9-23 Mackenzie Street, Melbourne

Planning Permit Application 2014/000838

Figure 2- tower separation between 33M & 36-40 La Trobe Street

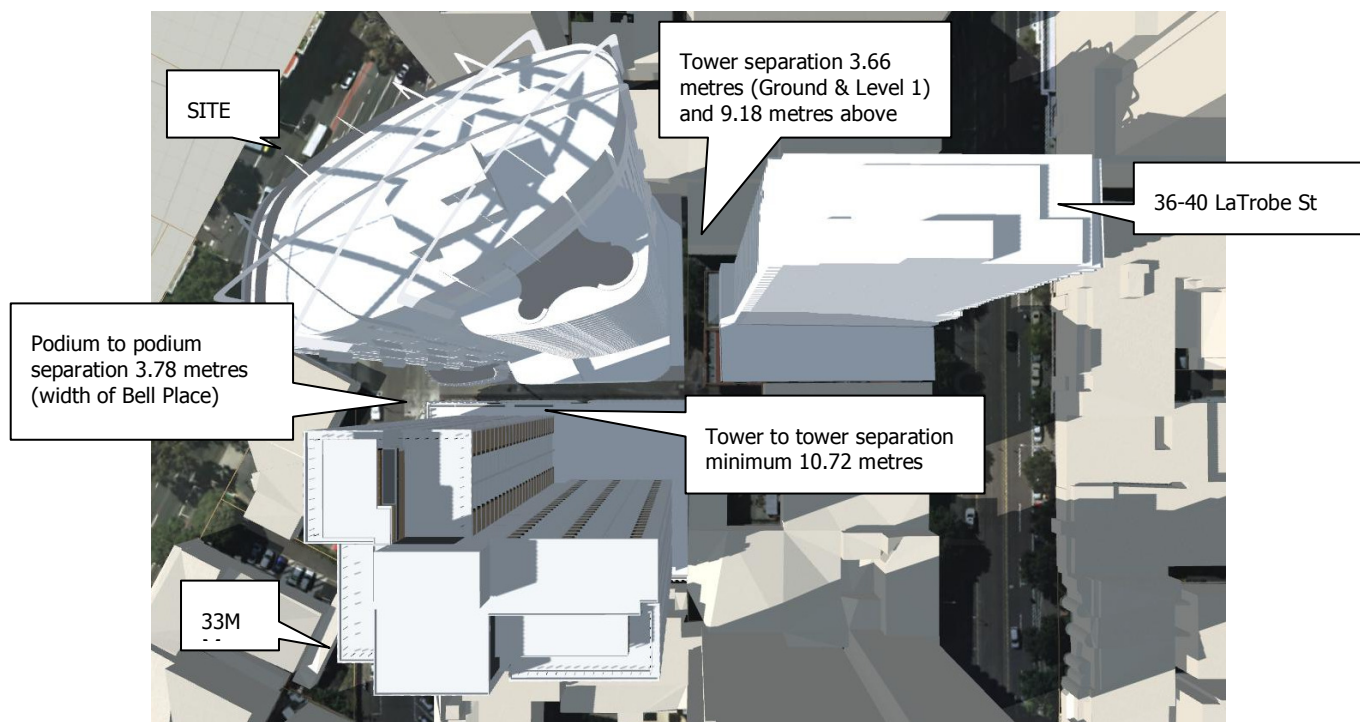
The key issue relates to the building interface with the existing apartment building at 33M and the approved redevelopment at 36-40 La Trobe Street. The relationship, including distances to the adjoining sites is demonstrated in **Figure 2** below.

The development at 33M includes an L shaped tower form, where the closest interface with the site includes the form towards the northern portion of the site. The podium to podium tower offset is the width of Bell Place, 3.78 metres, and provides a minimum of 10.72 metres between the towers. The

podium separation includes screening to avoid direct views. Details of this should be provided as a condition of any approval. The tower separation (above podium) is considered to be appropriate and provides a reasonable degree of separation. Combined with the offset of the finished floor level through the two buildings (an offset of 2.3 metres) avoids direct views into habitable rooms.

The redevelopment approved at 36-40 La Trobe Street (south of the site) includes built form to the northern boundary at ground and first floor, with upper balconies and living areas of 2.69 metres from its northern boundary. Tower separation is 3.66 metres at the lower levels and 9.18 metres above (refer to **Figure 2** above). During the consideration of the application, improving the amenity of the redevelopment of 36-40 La Trobe Street was carefully considered and resulted in the proposal being setback from its boundary from Level 1 in order to provide reasonable amenity to this site. An increase in this setback to 5 metres from the centre of the laneway would further alleviate amenity concerns to this site. This can be a condition of any approval to issue.
